Access Compliance Report

Public Rights-of-Way

(Curb Ramps)

Intersection ID: 44303	Main Street: PAULINE_LN	Cross Street: THOMPSON_RD	Location: NW
ADA ID: BCCCC08D06F0	Ramp Type: PerpDiag	Initial Pass/Fail: Pass	Overall Compliance: No
Severity Score: 5			
Codes/Mitigation Info/Possible Solution		Field Measurements/Component Compliance

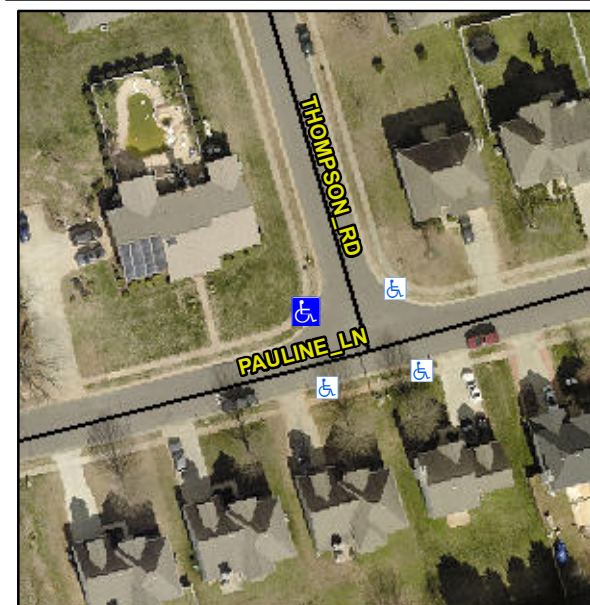
R304.2.1, R304.2.2-Perp, R304.3.2-Para, R305.2, R304.5.4

Remove & Replace Curb Ramp With Two New Directional Ramps or Equivalent. Remove & Replace Gutter.
